(Special Advisory No.18-2A supersedes and voids Special Advisory No.18-2 dated September 19, 1989)

SUBJECT: Aileron and Flap Hinge  
Bracket Attaching Hardware

REASON FOR REVISION: To revise Serial Numbers  
Affected and to modify the  
Purpose

MODELS AFFECTED: PA-18-150 Super Cub  
SERIAL NUMBERS AFFECTED: 1809002,1809004 through  
1809022

FIG. 1 VIEW OF TRAILING EDGE OF WING  
LOOKING UP

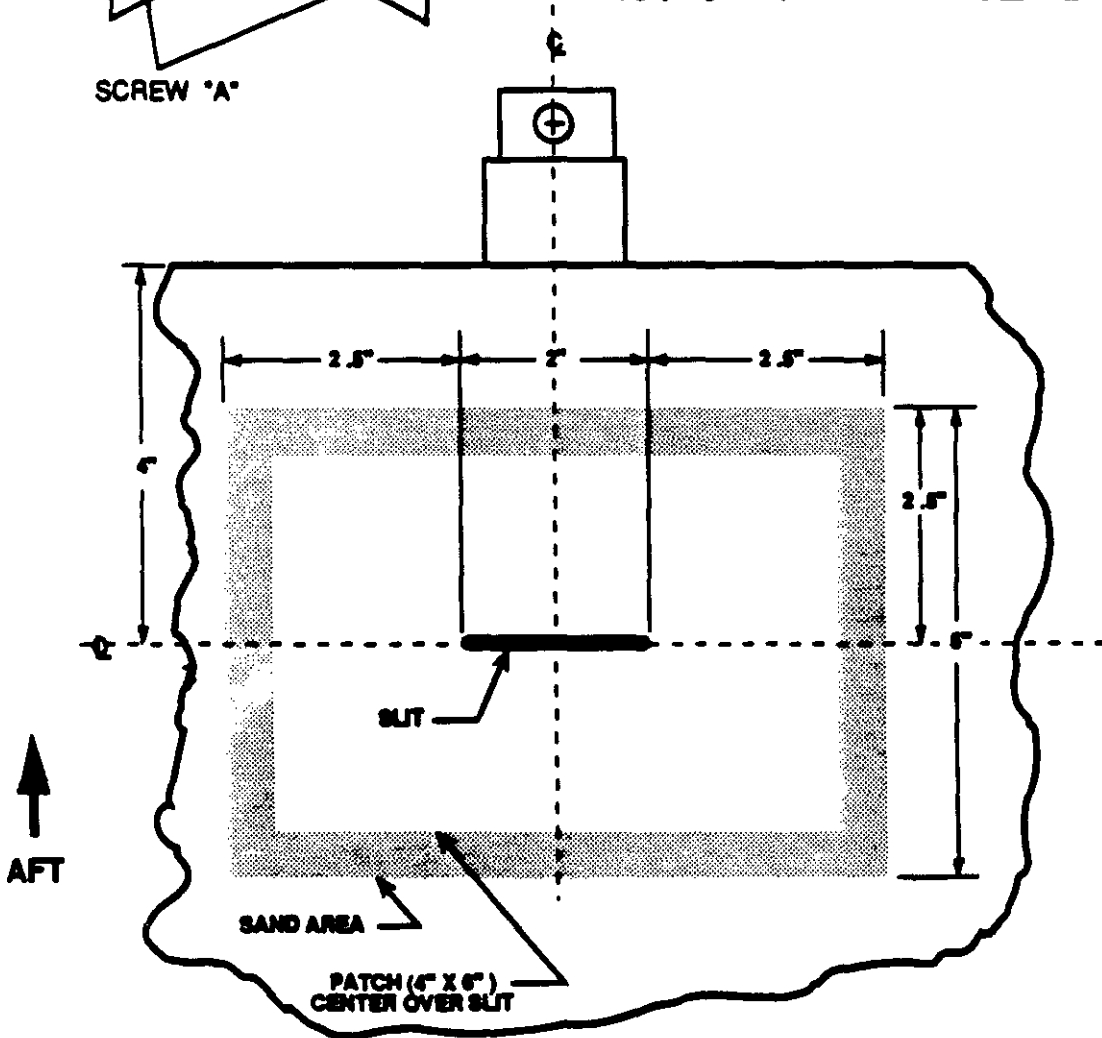
1. Locate each aileron and flap hinge bracket on left and right wings.
2. Measure approximately four (4) inches forward of the false spar at each hinge bracket on the underside of the wing to locate inspection slits.
3. Cut the inspection slit, spanwise two (2) inches, one inch each side of hinge center line.

Prior to cutting an inspection slit, check the airframe logbook for type of finish, then clean and sand the area per the instructions on Sketch "A", Fig. 1.

13. Apply fabric patches (use Blue River 7600 Material) to underside of wing and dollar patches (use Piper Part Number 89209-002 Patches) as necessary to the false spar where screws were removed per the instructions on Sketch "A".

FIG. 2

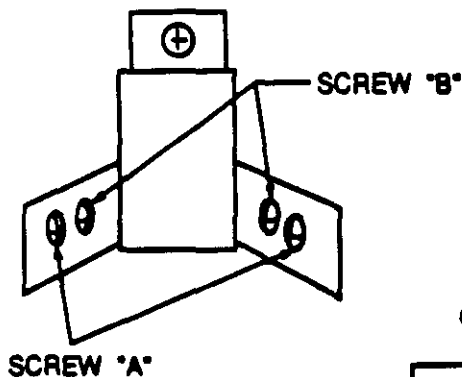
11. Install one (1) each rivet, Piper Part Number 523-121 (NAS1768D-4-2) in each hole where a screw was removed.
12. If it is necessary to remove all four (4) screws in any one bracket, refer to Sketch "A", Fig. 2. Remove screws "A" first and install rivets. Then remove screws "B" and install rivets.
